Access Compliance Report

Public Rights-of-Way

Intersection ID: 44540	Main Street: NEAL_RD	Cross Street: UNIVERSITY_CITY_BV	Location: S
ADA ID: 3C105A21A89B	Ramp Type: Perp	Initial Pass/Fail: Fail	Overall Compliance: No
Severity Score: 21.25			
Codes/Mitigation Info/Possible Solution		Field Measurements/Component Compliance

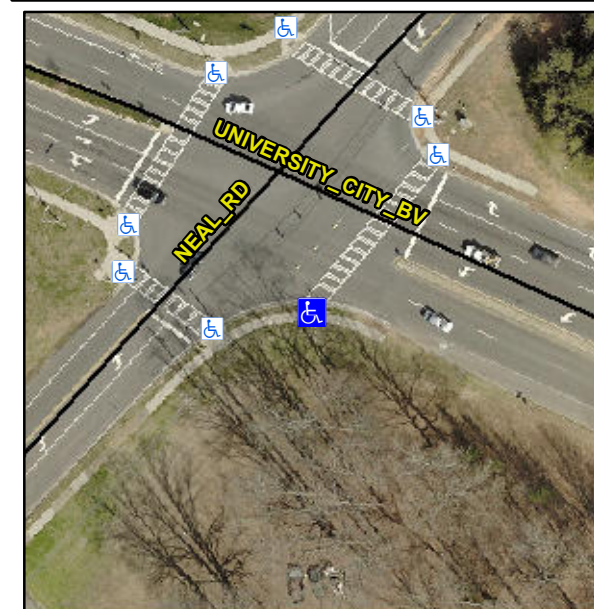
Not Found, R304.5.1, R304.2.2

Compliance	Description	Data	Compliance	Description	Data
N/A	Ramp Length (in)	48.0	No	Ramp Slope (%)	9.0
No	Ramp Width (in)	47.0	Yes	Ramp XSlope (%)	1.0
N/A	Flare Type LT	N/A	N/A	Flare Type RT	N/A
N/A	Flare Slope LT (%)	N/A	N/A	Flare Slope RT (%)	N/A
N/A	Flare Traversable LT?	N/A	N/A	Flare Traversable RT?	N/A
N/A	Landing Length (in)	N/A	N/A	DWS Provided?	N/A
N/A	Landing Width (in)	N/A	N/A	DWS Contrast?	N/A
N/A	Landing Slope (%)	N/A	N/A	DWS Length (in)	N/A
N/A	Landing X Slope (%)	N/A	N/A	DWS Full Width?	N/A
N/A	Landing Curb? (Y/N)	N/A	N/A	DWS Offset (in)	N/A
N/A	Shared Landing?	N/A			
N/A	Gutter Ponding?	N/A	N/A	Gutter Slope (%)	N/A
N/A	Gutter Lip Ht (in)	N/A	N/A	Gutter X Slope (%)	N/A
N/A	Painted X Walk1?	Yes	N/A	Painted X Walk2?	N/A
	X Walk 1 Direction	To NE		X Walk 2 Direction	N/A
N/A	X Walk 1 Width (in)	103.0	N/A	X Walk 2 Width (in)	N/A
	X Walk 1 Slope (%)	1.0		X Walk 2 Slope (%)	N/A
	X Walk 1 X Slope (%)	0.8		X Walk 2 X Slope (%)	N/A

Remove & Replace Entire Ramp.
